### **REMARKS**

I hereby certify that this **AMENDMENT UNDER 37 C.F.R. 1.111** is being deposited with the United States Postal Service as first class mail in an envelope addressed to: Mail Stop Amendment, Commissioner for Patents, P.O. Box 1450, Alexandria, VA 22313-1450 on or before 9/26/06.

FIG. 7

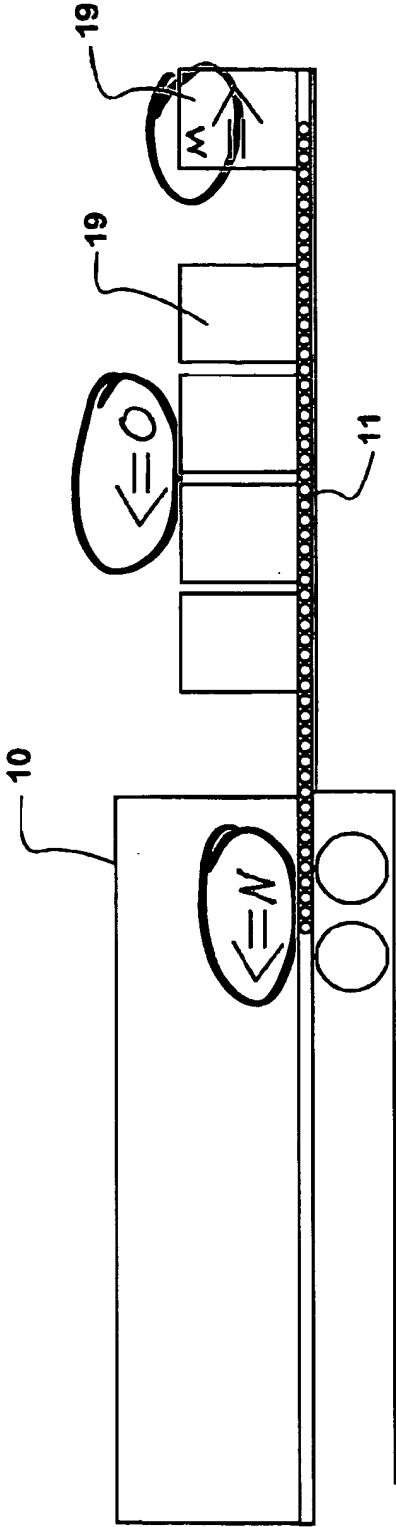
palletized freight module is called out by the letter "W". Similarly the letter "B" now refers only to a platform position. Rotation of the end segment is referred to by the letter "I". "N" has replaced "B" in Fig. 7 to indicate the direction of withdrawing the platform into a trailer. The step of Fig. 11 is redesignated "R". The freight module formerly referenced as "B" is now referenced by "X". Regarding the letter "C", its use in Fig. 11 to refer to a step has been changed to "S" and the freight module is now "Y". Use of the letter "D" in Fig. 11 to refer to a freight module has been changed to "Z" and to a step in the Figure to "T". Step "E" in Fig. 11 has been changed to "U".

FIG. 11

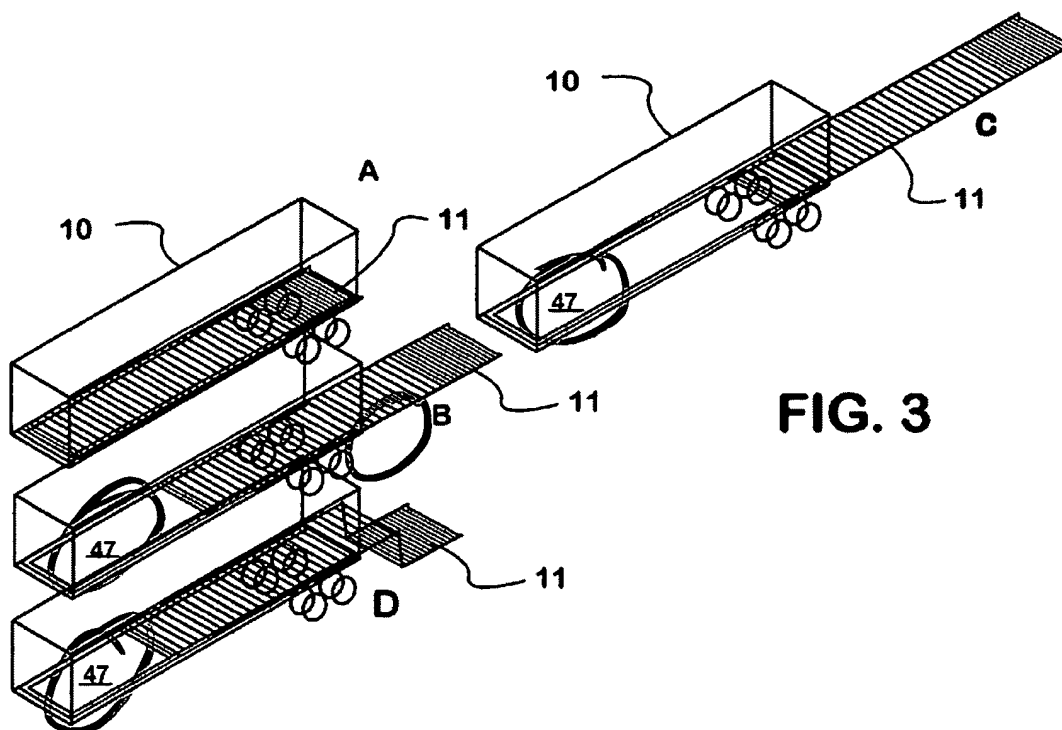
Regarding paragraph 2 of the Action, the reference numeral "13" now only refers to a target surface. The letter "A" now refers only to the retracted position of the bed. Rotation of the mid-section is referenced using the letter "H". The step of Fig. 11 formerly designated using the letter "A" is now called out by the letter "Q", and the
